South Coast Air Quality Management District

July 1, 2020

Draft Environmental Impact Report (Draft EIR) for the Proposed Sunset Gower Studios Enhancement Project (SCH No.: 2018021071)

Figure 1: South Coast AQMD Staff's Estimated Haul Truck Trip Distance based on the Haul Route in the Draft EIR

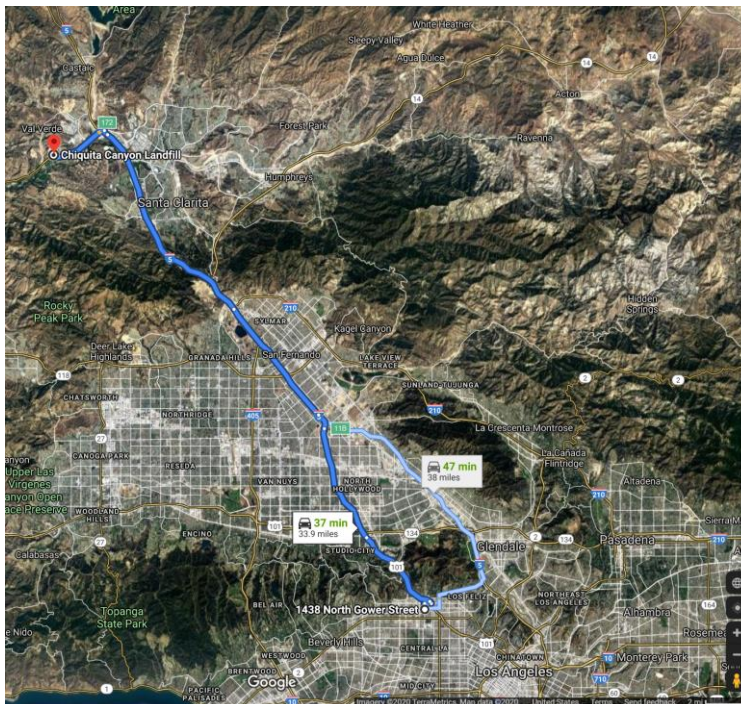
Based on a review of the Draft EIR and the Air Quality and Greenhouse Gas Analysis Technical Appendix, South Coast AQMD staff found that the Lead Agency used a haul truck trip length of 25 miles (one way)⁹ to quantify the Proposed Project's hauling emissions from soil export. In the Transportation Appendix to the Draft EIR, the Lead Agency stated that haul trucks will travel from the Proposed Project to the Chiquita Landfill via U.S. State Route 101 and Interstate 5 (I-5)¹⁰. However, the Draft EIR and supporting technical appendices, the Lead Agency did not discuss how the haul truck trip length of 25 miles (one way) was developed. As shown in Figure 1, South Coast AQMD staff estimated the haul truck trip length of 33.9 miles (one-way) between the Proposed Project and the Chiquita Landfill via U.S. Route 101 and I-5. The Lead Agency estimated that the peak truck activity at the Proposed Project would occur during the excavation and grading phases and would require up to 314 truck trips a day¹¹. Using a one-way haul truck trip length of 25 miles likely underestimated the Proposed Project's construction emissions, particularly NO_x emissions, from haul truck trips for soil export. Therefore, South Coast AQMD staff recommends that the Lead Agency provide additional information in the Final EIR as substantial evidence to support the use of 25 miles (one-way). Alternatively, to conservatively analyze a worst-case construction impact scenario, the Lead Agency should re-calculate the Proposed Project's construction emissions from haul truck trips based on a 33.9-mile, one-way trip length. If the Lead Agency finds, after the revisions, that the Proposed Project's construction emissions would be significant, mitigation measures to reduce hauling emissions will be required (CEQA Guidelines Section 15126.4). (Also see Comment No. 3).
